**SECTION 00 90 02
BIDDING AND CONTRACT REQUIREMENTS
ADDENDUM NUMBER 2**

Issued: November 1, 2024

Re: ADDENDUM NUMBER (2) TO THE BIDDING DOCUMENTS FOR

**McHenry County College
2024 Renovations – Bid Package 2**
Architect's Project Number: 24-013

SHEET NUMBER:
AD1.11

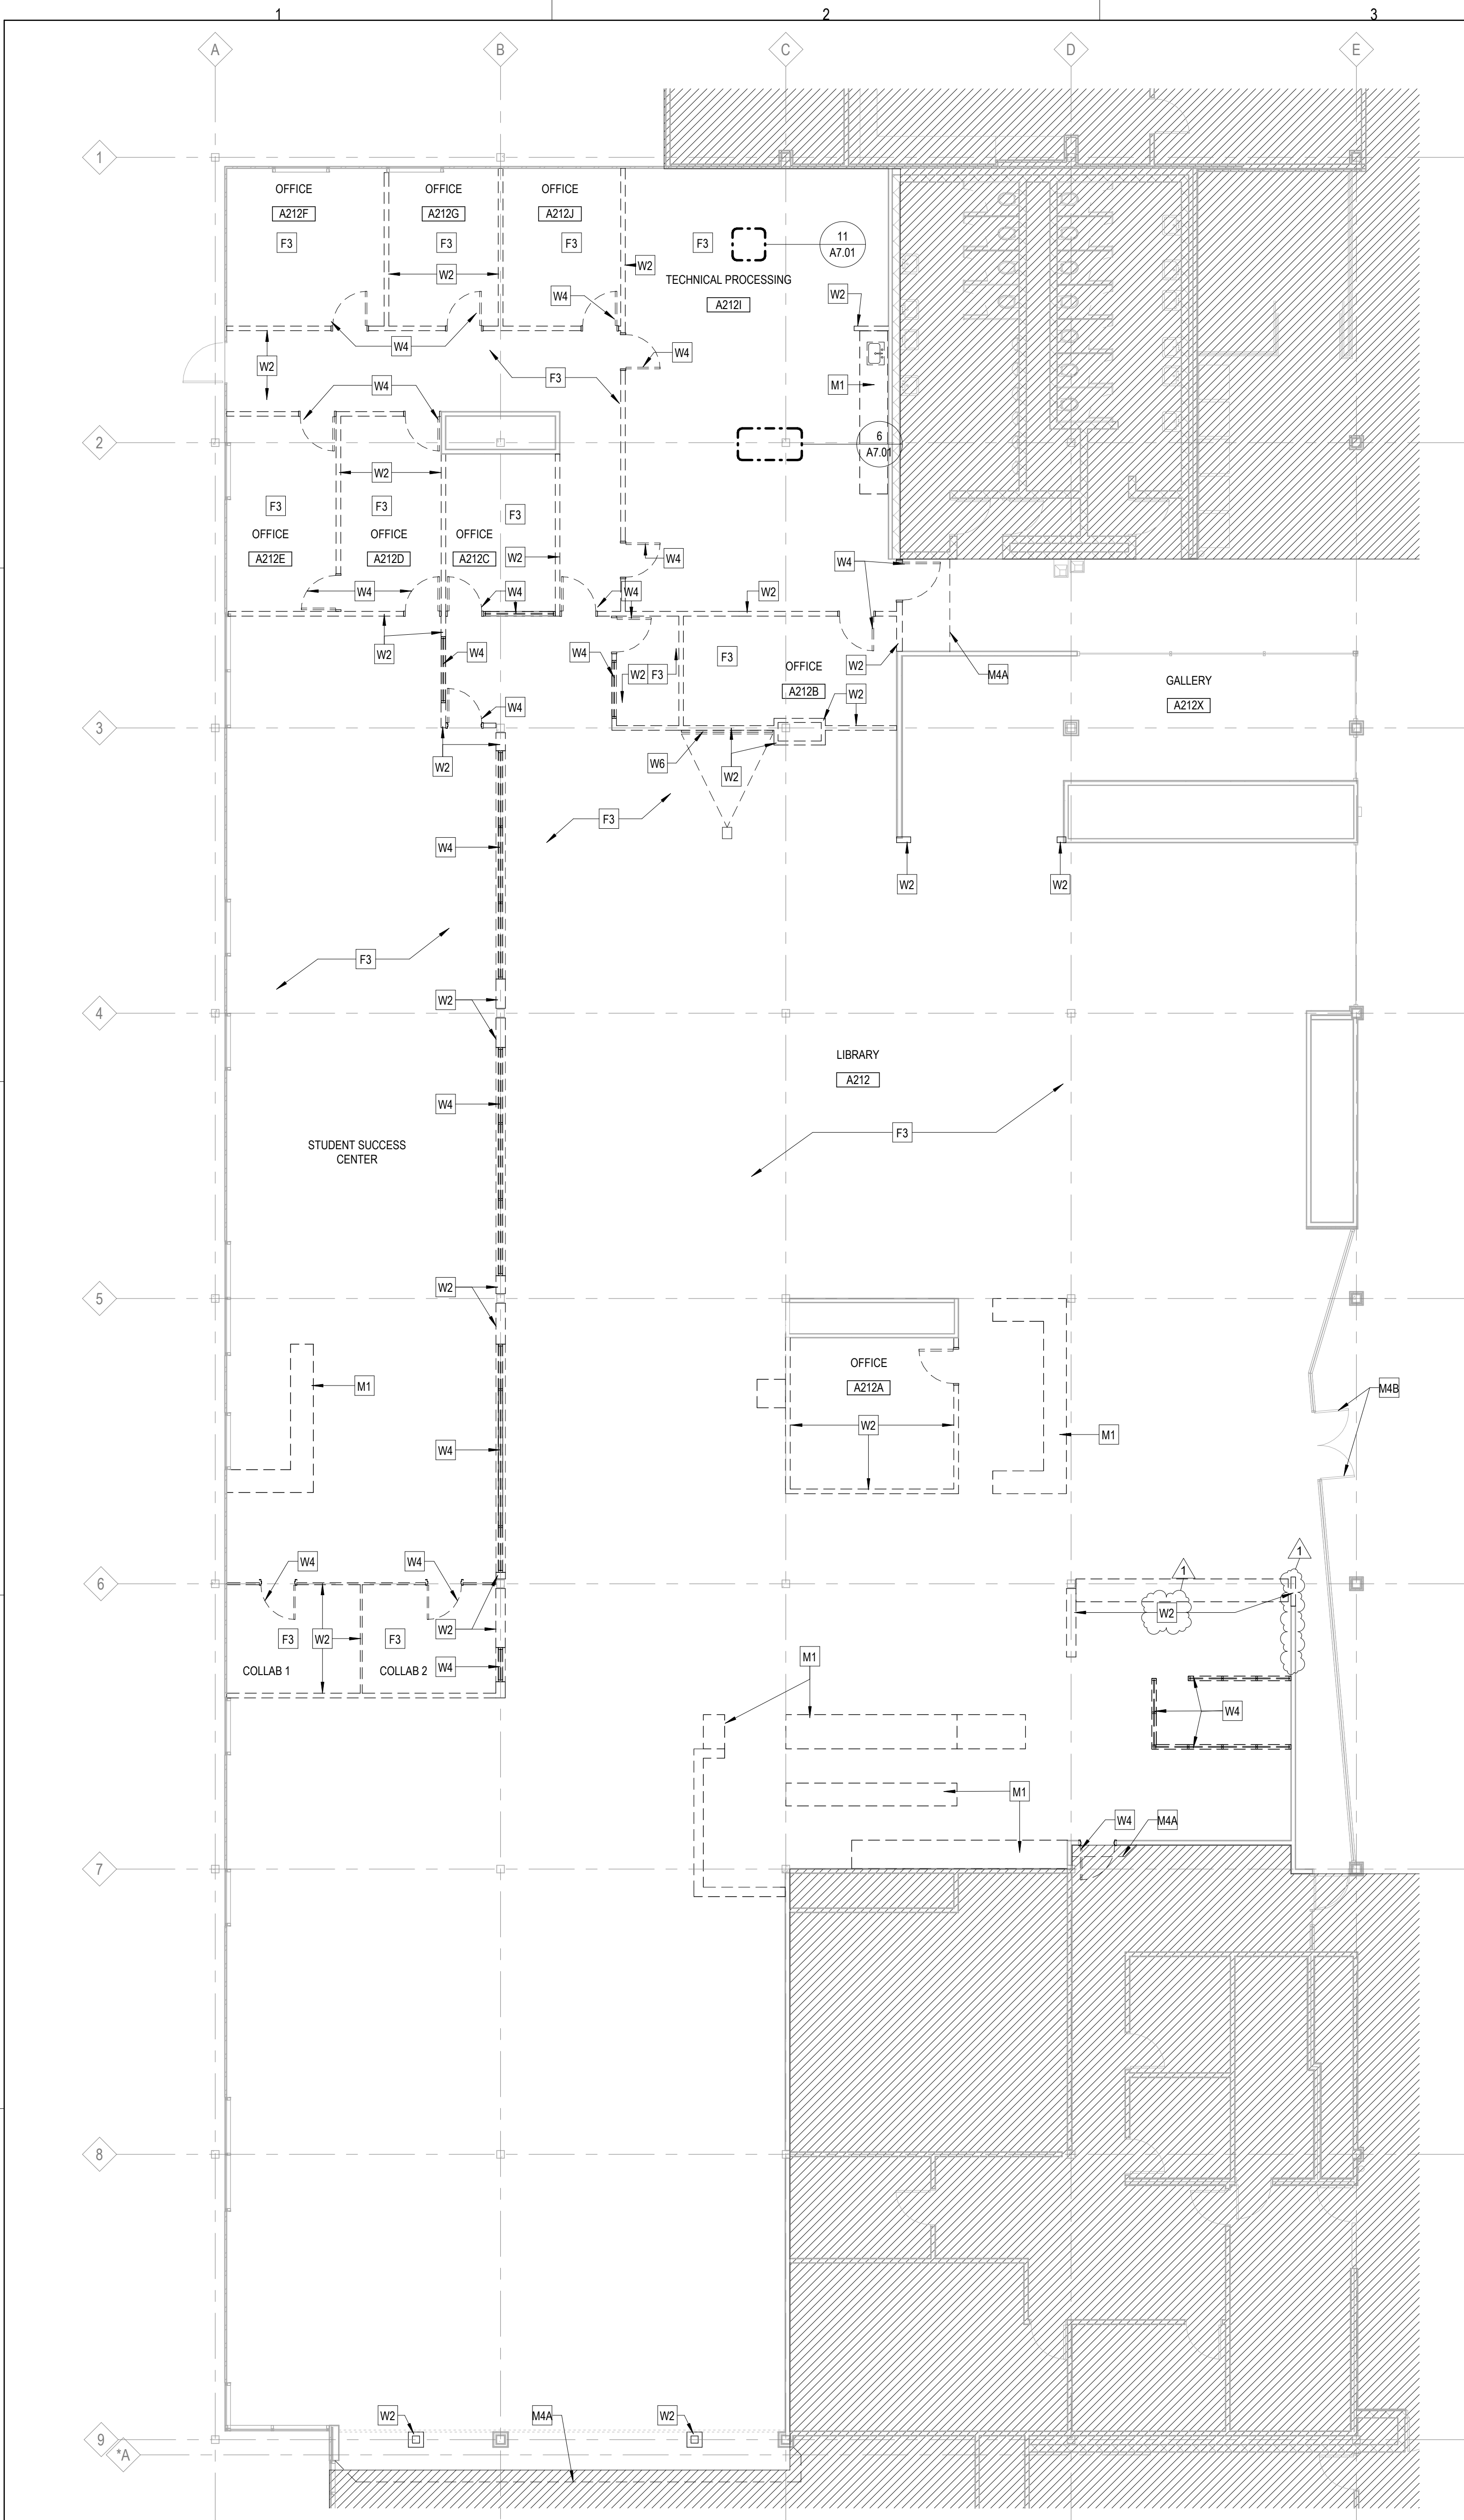
1. AD1.11
 - A. **ADD** Demo Referenced Note F7.
 - B. **REVISE** F3 demo note in EMS LAB to F7.
2. AD1.20
 - A. **REVISE** demolition extent of existing South Gallery wall.
3. AD2.20
 - A. **REVISE** demolition extent of existing South Gallery wall.
 - B. **REVISE** existing window layout and associated scope to demolish the existing window blinds.
4. A1.11
 - A. **ADD** scope of Floor Plan Reference Note 13 for continuous blocking to plan as indicated.

1 FLOOR PLAN - LIBRARY
1/8" = 1'-0"

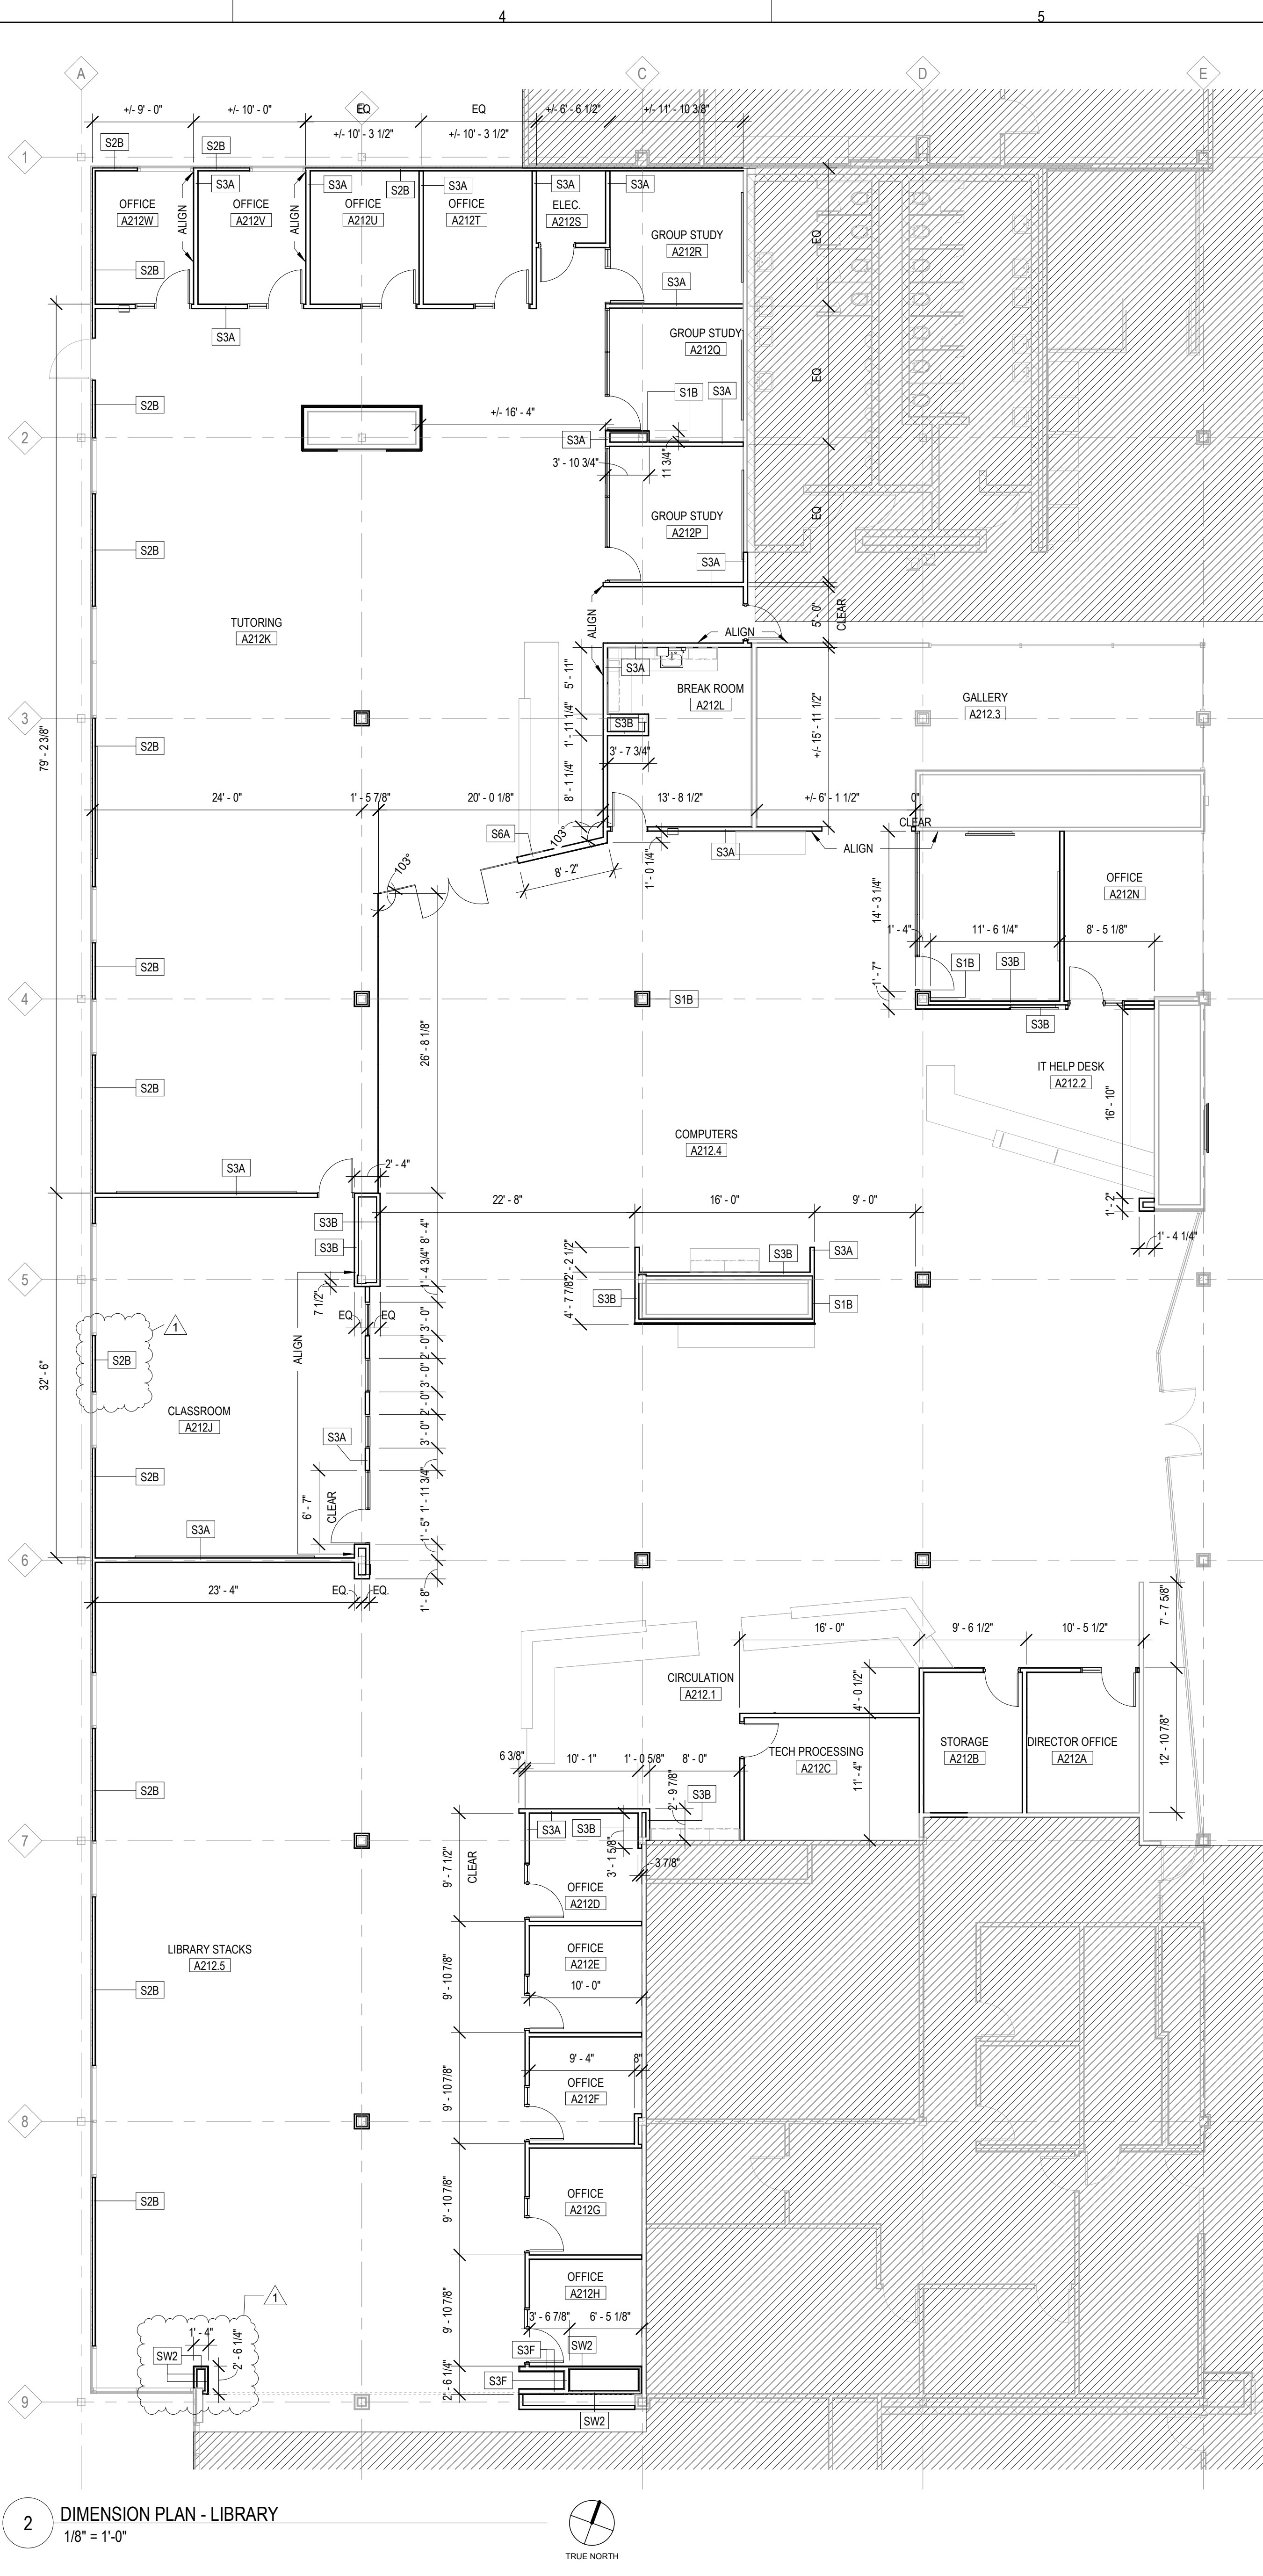
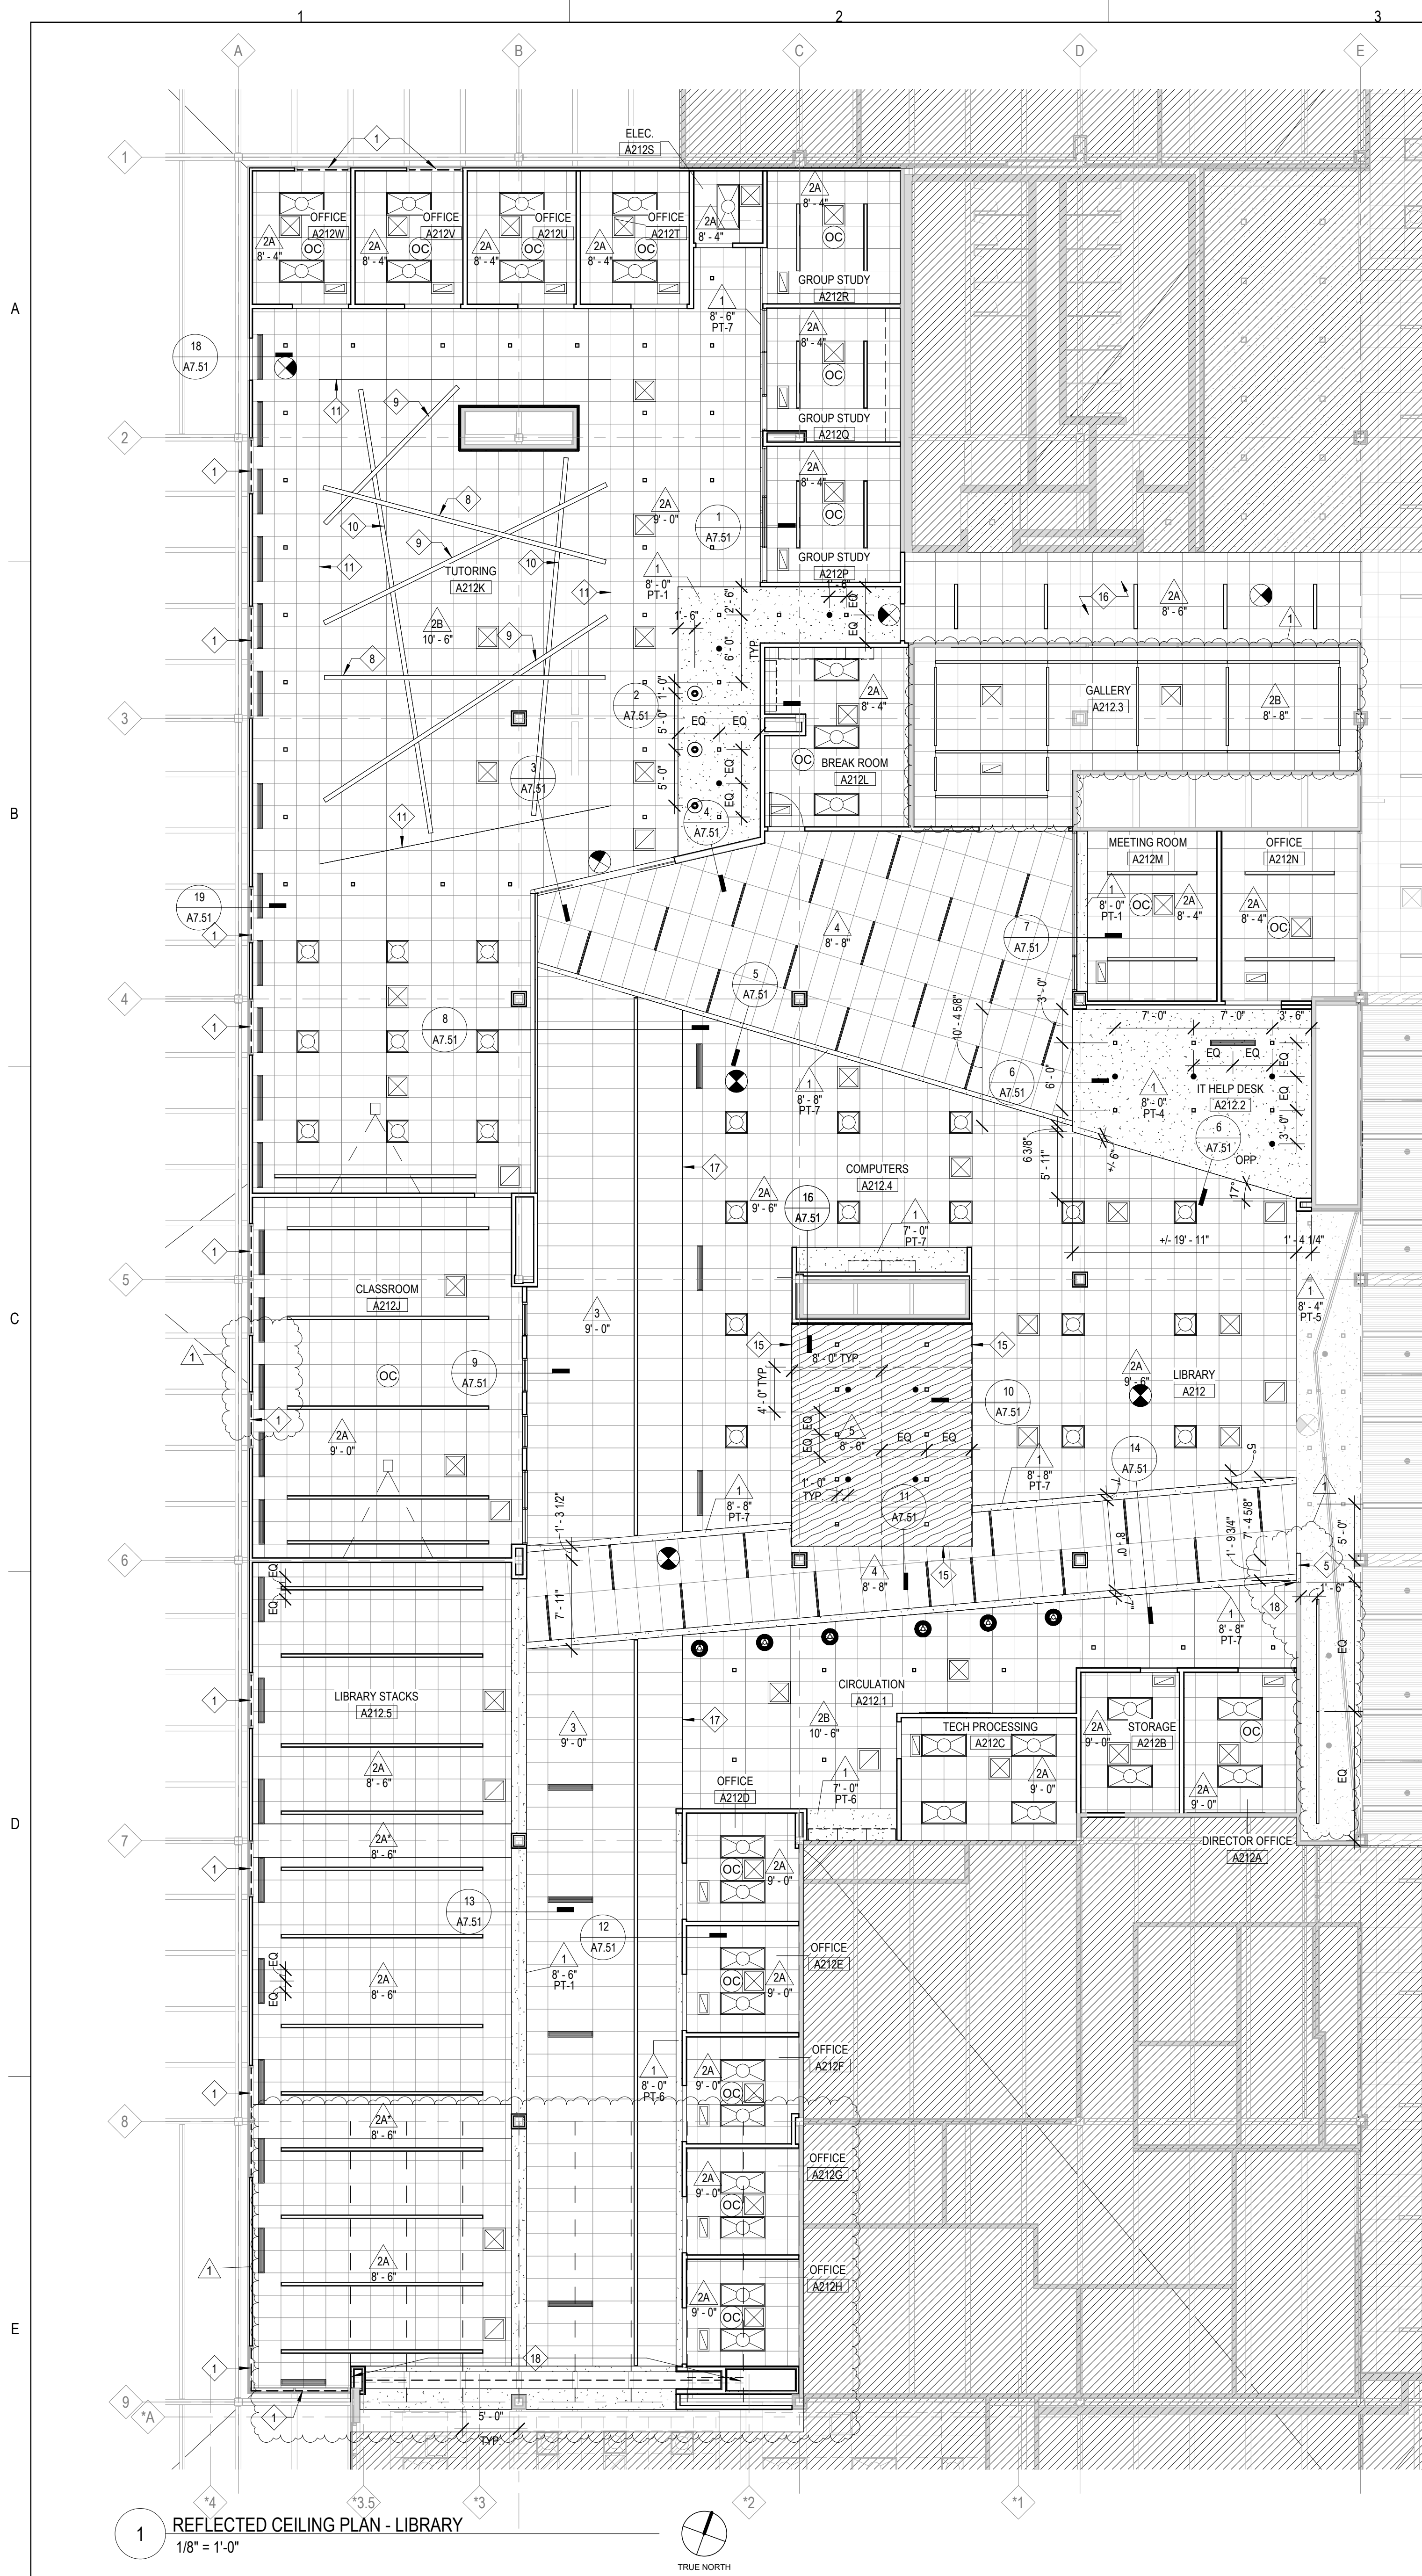
5. A1.20
 - A. **DELETE** pole mount TV.
 - B. **REVISE** Referenced Note 9 to refer to the fire rated folding door in lieu of pole mount tv.
 - C. **REVISE** existing Gallery wall near DIRECTOR OFFICE A212A as indicated.

- D. **ADD** monitor and Power/ Data to existing corridor wall outside of Library. Refer to Elec.
 - E. **REVISE** existing window layout and associated furring walls as indicated on Library Floor Plan and Dimension Plan.

- F. **DELETE** Millwork cabinets and countertop from TECH PROCESSING A212C and associated enlarged plans and details. Scope of millwork in this area no longer included in the project.

- G. **ADD** scope of Floor Plan Reference Note 13 for continuous blocking to plan as indicated.
 - H. **ADD** fire extinguisher cabinets as indicated. Refer to plan for types.
